Review of Adequacy of Environmental Mitigation in the ESIA for the East Africa Crude Oil Pipeline

May 12, 2019

Bill Powers, P.E., E-Tech International

Figure 5. Photographs of the open-cut buried pipe section that ruptured and the replacement pipeline bridge¹⁸

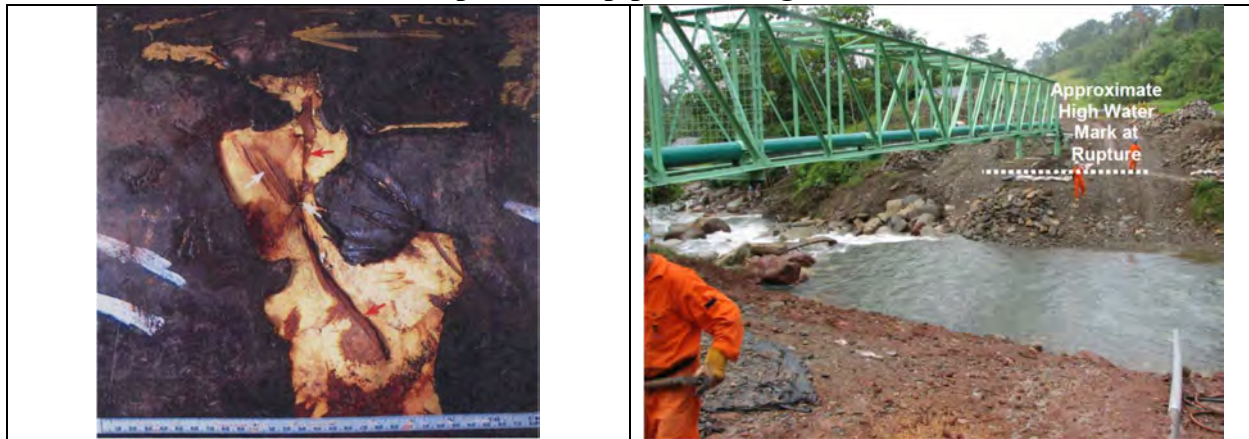
Open-cut trenching of pipelines in streambeds carries operational risks. A major rupture on the Camisea liquids pipeline in Peru occurred sixteen months after the pipeline began operation at a point where the pipeline had been placed under the streambed of the Paratori River using open-cut trenching.¹³ The river is less than 10 meters across where the rupture took place. The pipeline was exposed due to scouring of the streambed during a period of heavy rain.¹⁴ It had been buried 2.1 meters below the stream bed.¹⁵

The automatic leak detection system did not register that a leak had occurred. The pressure reduction caused by the rupture “*was not sufficiently large to activate the automatic rupture detection mechanism of the block valves upstream and downstream of the rupture.*”¹⁶ The rupture was detected when control room operations staff identified a reduction in flow at the downstream pump station. The nearest block valves were ultimately closed about one hour after the rupture occurred. Approximately 4,600 barrels of liquid hydrocarbons were spilled into the stream.¹⁷ Figure 5 shows the damaged pipe section and the pipeline bridge that replaced the pipeline section that had been buried under the streambed.

In summary, HDD is best practices for traversing the ten major waterbody crossings along the pipeline route in Uganda. As noted, the total width of these ten waterbody floodplains is approximately 2 km. HDD has no construction footprint on the waterbody itself. HDD has no construction footprint on the waterbody itself. In contrast, open-cut has a large and negative footprint, at least temporarily, on the waterbody. Therefore about 2 km of HDD will be necessary to traverse these ten waterbody floodplains.

Figure 6. Schematic of horizontal directional drilling under a river¹⁹

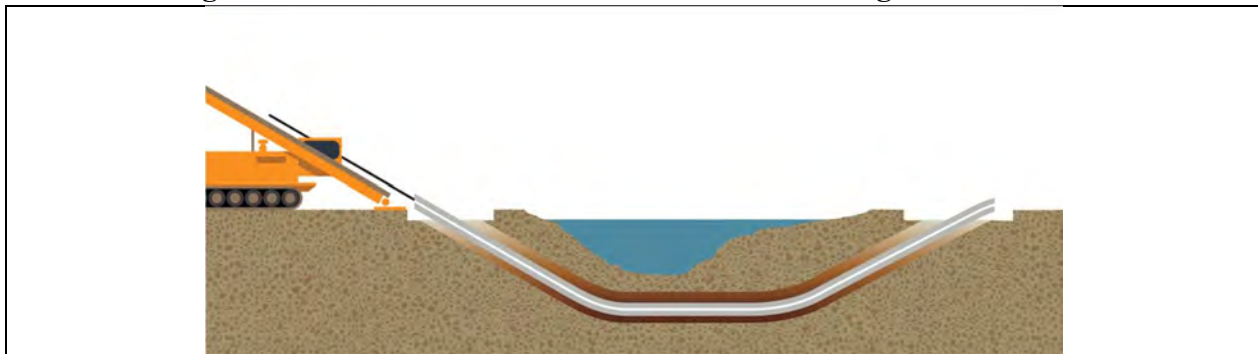
The HDD technique involves drilling under the waterbody and avoiding any disruption to the waterbody itself. See Figure 6.

It is important to underscore that HDD must be done properly to achieve the intended environmental and water quality protection purposes. There will be strong pressure in the field to keep laying pipe sections as fast as possible. A clear, detailed and sufficient work plan must be developed for each HDD crossing, and onsite independent inspection must verify that the work plan is being followed.
